SERVICE BULLETIN

REVISION 7 To Service Bulletin SB-T-01-1300/1400-001

**RDR-1300B/1400B WEATHER RADAR SYSTEM
RT-1301B/1401B RECEIVER-TRANSMITTERS**

PFN CAPACITOR AND TRIGGER TRANSFORMER REPLACEMENT

Figure 1. Modulator Parts Location

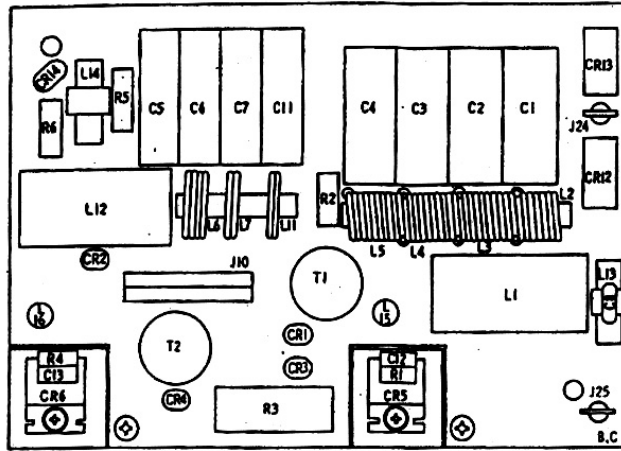
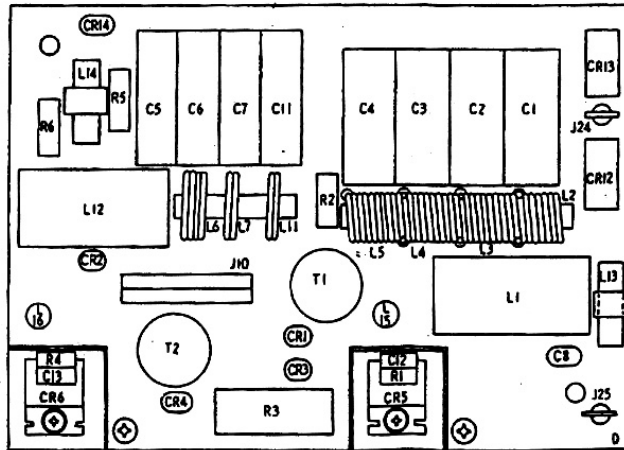
- h. Using Figure 1, Modulator Parts Location, locate C4001, C4002, C4003, C4004, C4005, C4006, C4007, C4011, T4001, and T4002
- i. In accordance with instruction in I.B. 21401B/I.B. 21401-1 Section III, paragraphs 6C and F, remove capacitors C4001 thru C4007, C4011, and trigger transformers T4001, and T4002.

- Replace C4001 with 10238-0001
- Replace C4002 with 10238-0001
- Replace C4003 with 10238-0001
- Replace C4004 with 10238-0001
- Replace C4005 with 109-10384-0001
- Replace C4006 with 109-10384-0002
- Replace C4007 with 109-10384-0002
- Replace C4011 with 109-10384-0002
